9-27-24 - Redlines - JJ  
 10-8-24 REMOVE GAS STUB OUTS  
 REMOVE KNEE WALL ISLAND -CW  
 Revise to show a shower instead of tub for bath 2 -10-18-24 - JJ  
 Rename Bed 5 to Game ROom - JJ - 10-24-24  
 11-4-23 Grab bars added in downstairs owners suite shower CW

PLAN 6  
 The Raleigh - RH  
 'FRENCH COUNTRY'  
 ELEVATION

PLAN 6 - THE RALEIGH - RH  
 SINGLE FAMILY  
 Cover Sheet 'French Country'

FIRST FLOOR PLAN 'FRENCH COUNTRY'

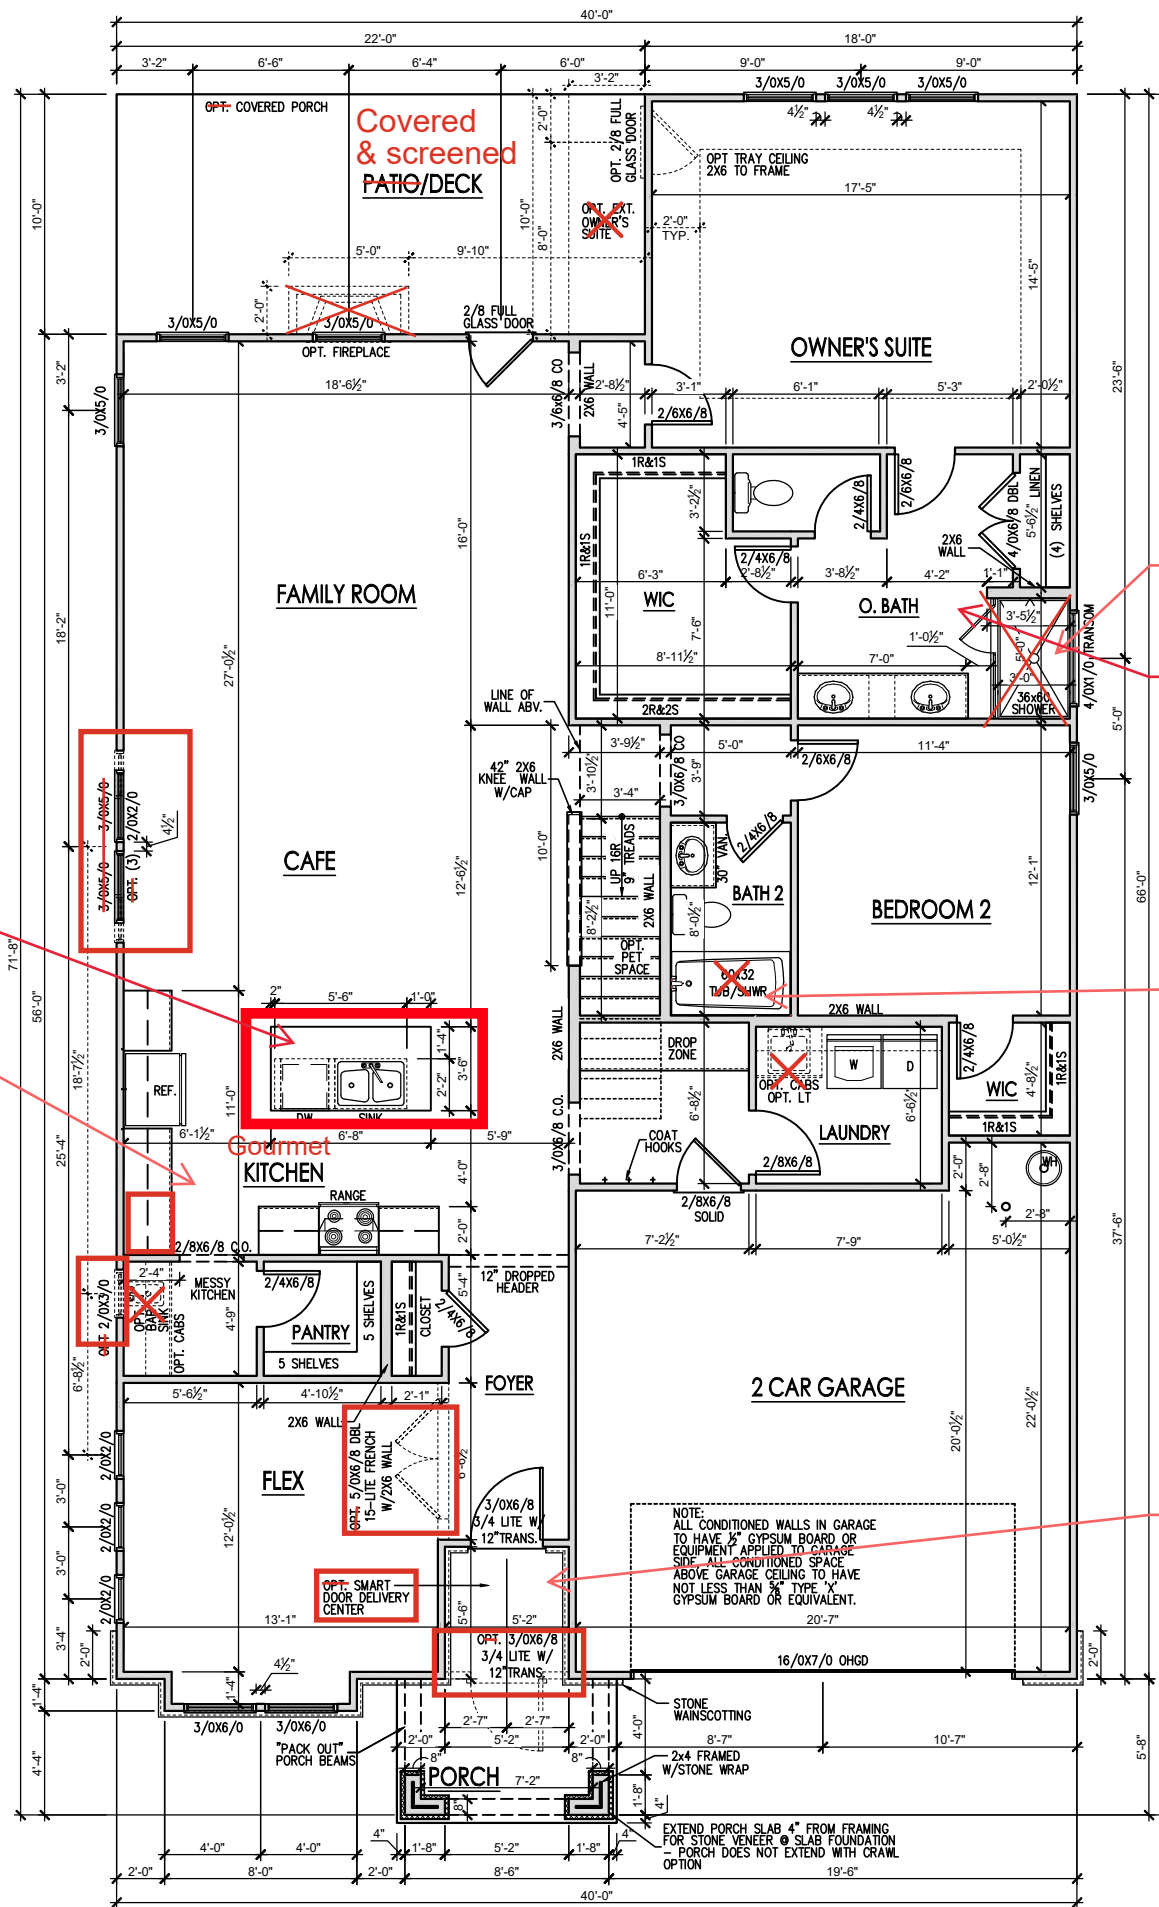
NO KNEEWALL Finished Cabinet Panel

install grab bar in shower

Shower ILO tub Shower: Fiberglass pan w/ tile surrounds

**PLAN 6 - THE RALEIGH - RH**  
SINGLE FAMILY  
First Floor Options 'French Country'

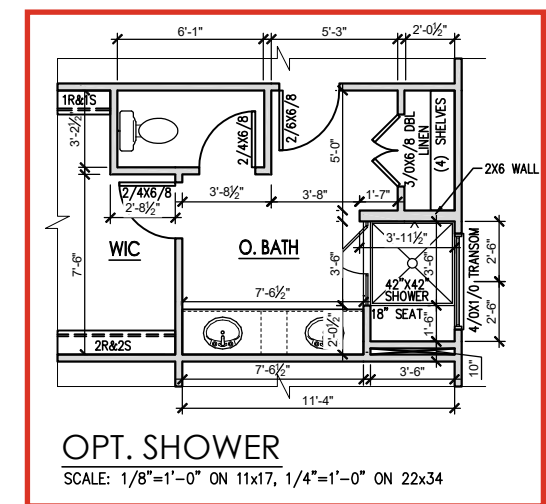
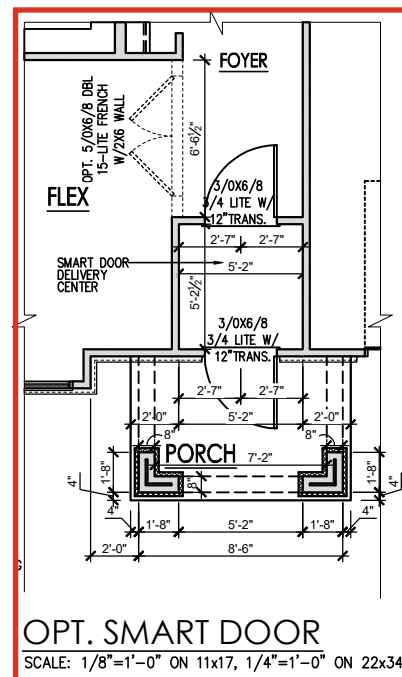
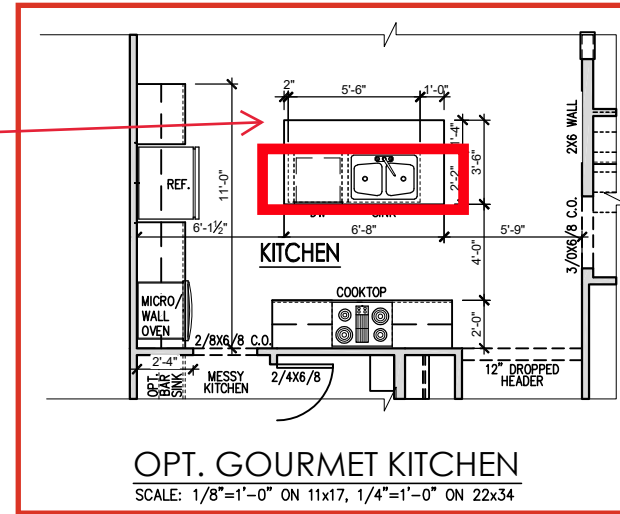
NO KNEEWALL  
FINISHED  
CABINET PANEL
